HISTORIC PRESERVATION COMMISSION

ALTERATION TO A HISTORIC PROPERTY STAFF REPORT

Site: 51 Davis Square c.1914 Hobbs Building/Somerville Theatre Case: HPC 2015.019 Single Building Local Historic District

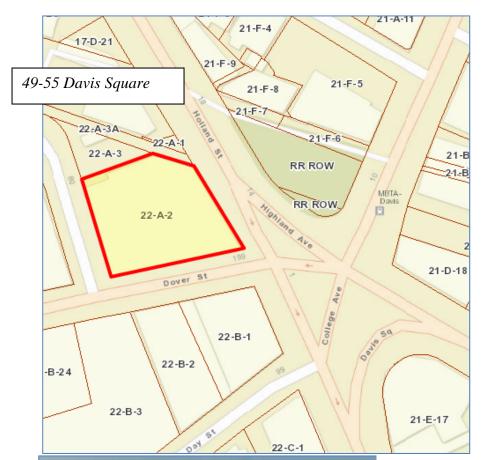
There will be no alterations or replacement to architectural features discussed in the Form B. The proposed alterations are located on the modern storefront system and not on the historic masonry. The materials used for the awning are "Sunbrella®", a woven synthetic fabric and a printed lettering. The awning protrudes from the building approximate 36", sufficient to provide some shading and protection to those beneath its canopy.

- 1. Two Sunbrella® awnings with lettering stating the name of the current business (Mr. Crepe) may be installed.
- 2. The awnings shall be one each of the following sizes: 30"high x 36" deep x 11'11" and 30"high x 36" deep x 17'4.5" on the modern storefront portion at 49-51 Davis Square.
- 3. The attachment of the awnings shall not affect the historic masonry of the building.
